# PLANNING

Project: **7 Warwick Court**

Drawing Title: **Demolition & Proposed First Floor Plan**

Drawing No. **P\_03** Rev. **D**

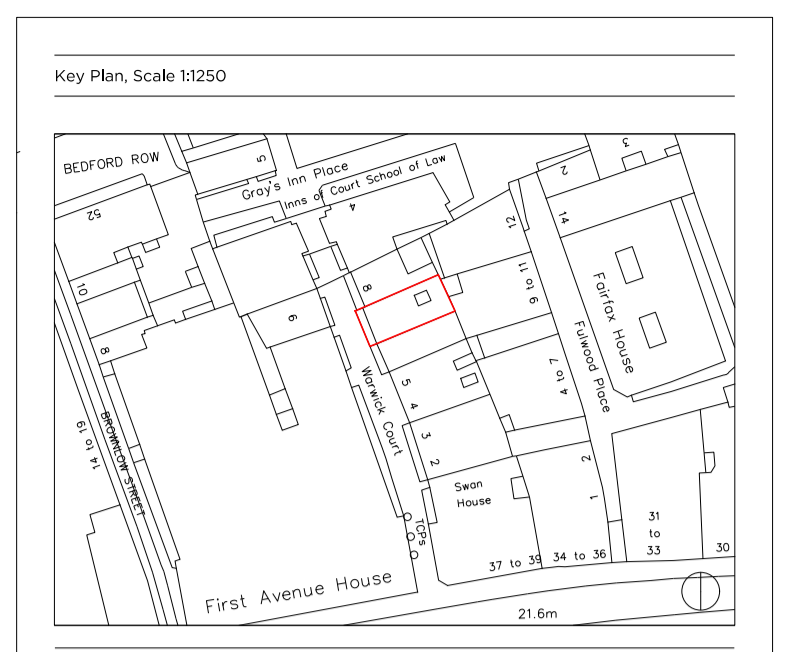
- D. Revision Notes:**
- D.1 Demolition of wall to allow for new floor.
  - D.2 Existing door fixed shut.
  - D.3 The addition of new door providing access into new reception room.
  - D.4 From this room is now a reception room for Flat 03.
  - D.5 Existing fireplace to be exposed and restored.
  - D.6 Proposed living area now bedroom II.
  - D.7 The addition of demountable gallery with partition and obscurity glazing.
  - D.8 Proposed kitchen now proposed family bathroom.
  - D.9 Proposed shower room now an ensuite to bedroom.
  - D.10 Glass partition removed.
  - D.11 Kitchen moved adjacent to reception room.
  - D.12 Addition of albrick (275x140mm).
